American Association of State Highway and Transportation Officials

An Application from the State Highway or Transportation Department of
Virginia

- the Elimination of a U.S. (I) Route _____
- the Establishment of a U.S. (I) Route _____
- * the Establishment of a U.S. Bike Route _____
- the Relocation of a U.S. (I) Route _____
- * the Relocation of a U.S. Bike Route 76
- the Extension of a U.S. (I) Route _____
- the Establishment of a U.S. Alternate Route _____
- the Establishment of a Temporary U.S. Route _____
- ** the Recognition of a Business Route on U.S. (I) Route _____
- ** the Recognition of a By-Pass Route on U.S. Route _____

The Virginia Department of Transportation (VDOT) requests two changes to the location of U.S. Bike Route 76

Figure 1: Proposed USBR 76 Relocation – Town of Christiansburg

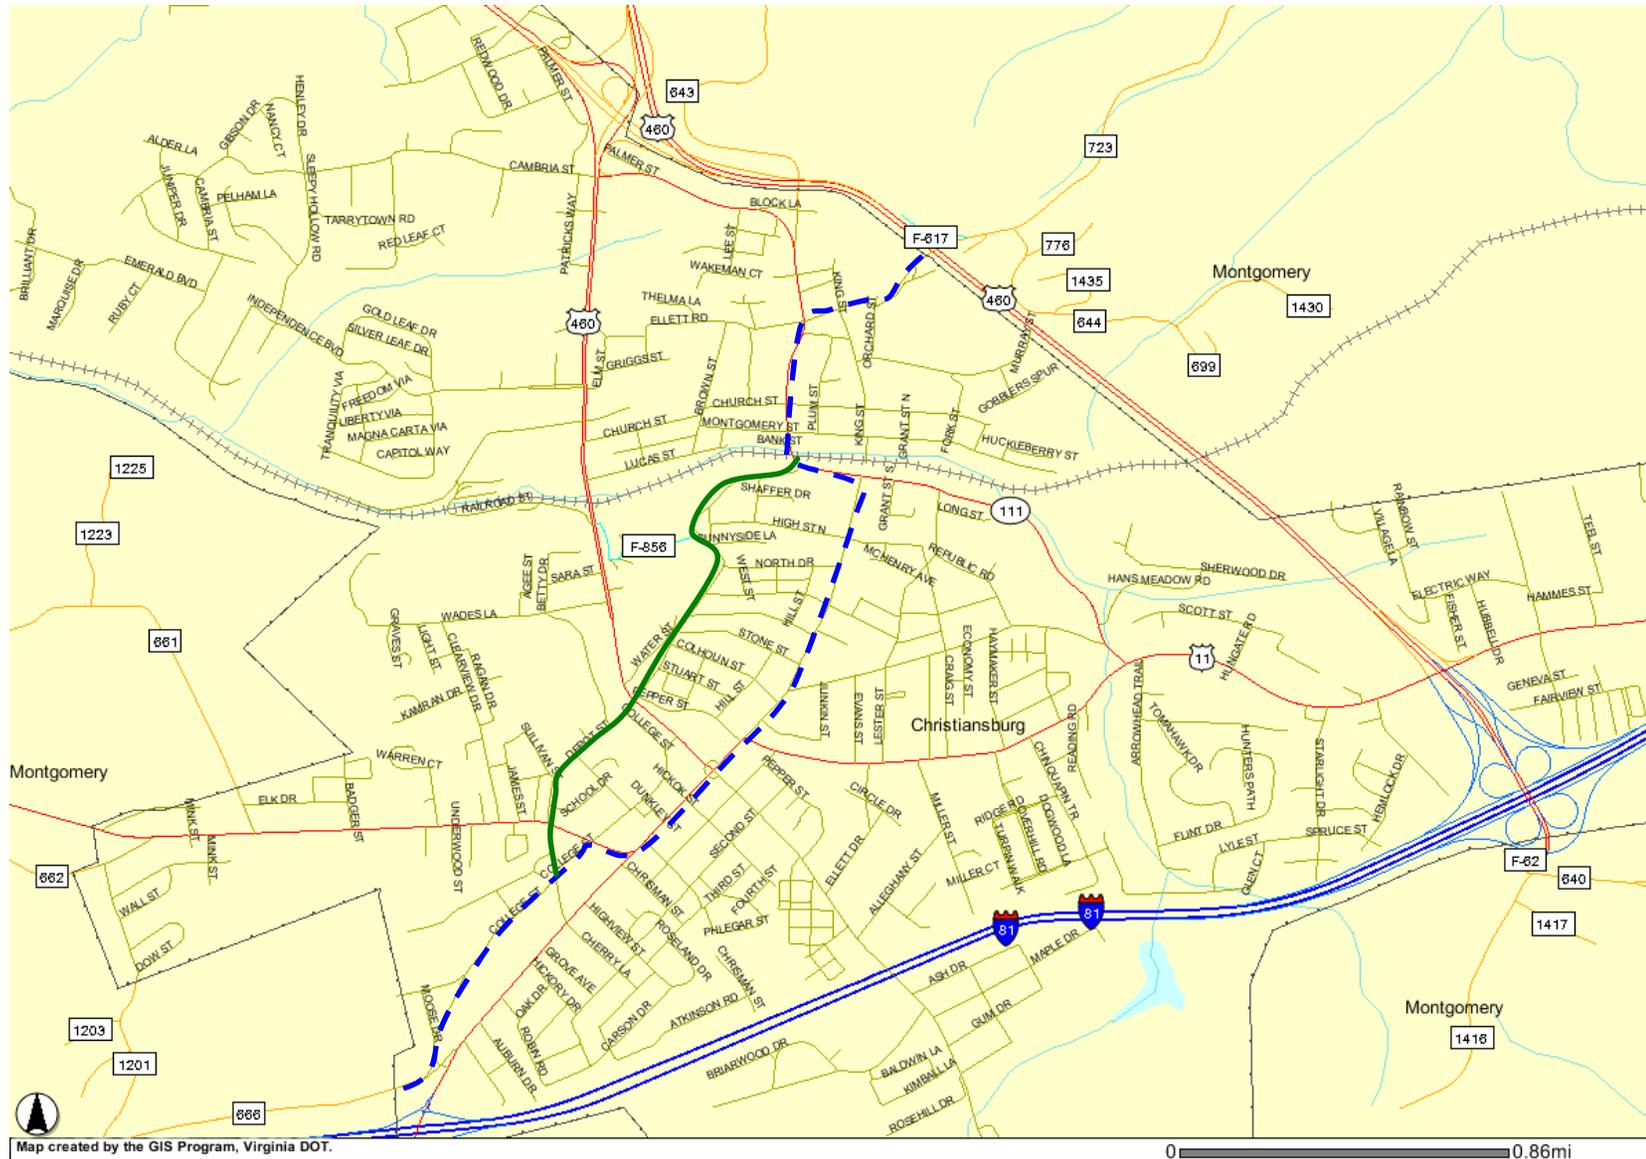
The first request is located in the Town of Christiansburg, and is intended to address bicyclist safety and route suitability concerns. Three (3) miles of USBR 76 are located in the Town of Christiansburg. The new routing would affect 1.5 miles of USBR 76 in Christiansburg (See Figure 1).

USBR 76 currently travels over a portion of Main Street that includes several hills, the steepest of which involves an elevation change of 130 feet over a distance of 0.17 miles. The existing Main Street route segment also passes through Christiansburg's downtown business district with on-street parking and three signalized intersections. The existing Main Street route is not well-suited for bicycle traffic.

The new routing would avoid Main Street altogether. Traveling from east to west, the new route segment would depart from the existing route at the intersection of Cambria Street and Depot Street. From that point, the new route turns west and follows Depot Street 1.5 miles to its intersection with College Street. At this intersection, the new route segment would rejoin the existing route which follows College Street to the south and west.

The new Depot Street route segment has the following characteristics: between Cambria Street (SR 111) and North Franklin Street (US 460-Business) (distance of 0.9 mi.), Depot Street is a two-lane facility with little or no shoulders, average lane width of 11 feet, 25 mph posted speed limit, and ADT of 2,600; between North Franklin Street and College Street (distance of 0.6 mi.), Depot Street is a four-lane facility (2 lanes in each direction) with curb and gutter, average lane width of 12 feet, 35 mph posted speed limit, ADT of 14,000 between North Franklin Street and Radford Street (US 11), and ADT of 10,000 between Radford Street and College Street. The new Depot Street route segment includes two signalized intersections (i.e., at North Franklin Street; and at Radford Street). Grades along this route are much more suitable for bicycle traffic. For long-distance bicyclists, an additional feature of this new route is that a grocery store is accessible from Depot Street.

Figure 2: Proposed USBR 76 Relocation – Henrico County

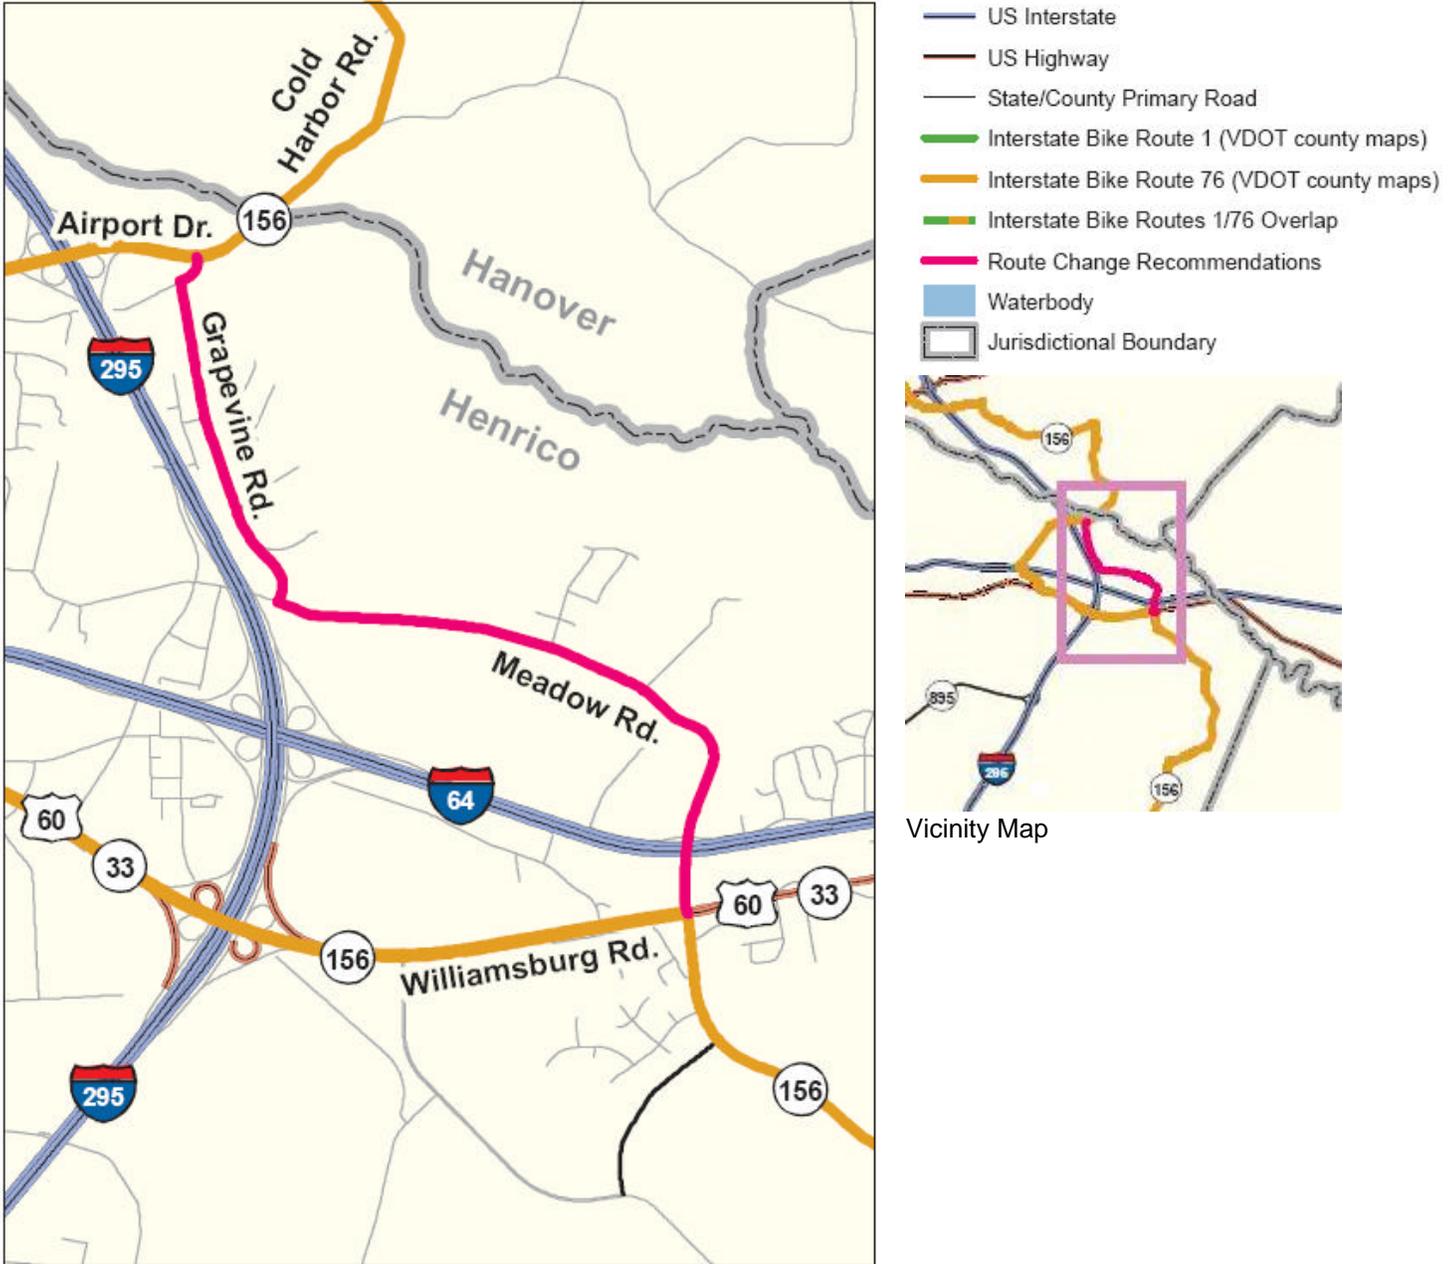
The second request is located in Henrico County, and is intended to address safety concerns for cyclists and other roadway users. It also brings the official designated route into agreement with existing signage. The change would affect 7.6 miles of the existing route. The new routing would be 4.2 miles long.

Traveling north, U.S. Bike Route 76 currently follows State Route 156 to U.S. Route 60 (Williamsburg Road). The route turns left and continues for 3.6 miles on U.S. 60 before turning right on State Route 33 at Sandston. It then turns right on S.R. 156 (Airport Drive) at Highland Springs and continues into Hanover County.

The relocated route proceeds straight across U.S. 60 onto Meadow Road. It continues on Meadow Road for 2.6 miles and then turns right onto Grapevine Road. At the end of Grapevine Road (1.5 miles), the route turns right on Old Hanover Road, continues for 0.1 miles and then turns right on S.R. 156 to rejoin existing USBR 76.

The proposed route avoids U.S. 60, which is a four-lane divided highway. This section of U.S. 60 has a posted speed limit of 55 MPH and carries significant truck traffic. It also has a cloverleaf interchange with I-295 that requires cyclists to traverse several long merge lanes. U.S. 60 has 8-foot shoulders, but the pavement is very rough. Airport Drive also carries a significant amount of motorized traffic and requires cyclists to cross a cloverleaf interchange with I-295. The proposed route eliminates these heavy traffic areas and two Interstate interchanges. It includes rural roads with good pavement and little traffic. In addition, the proposed route is currently signed as part of USBR 76.
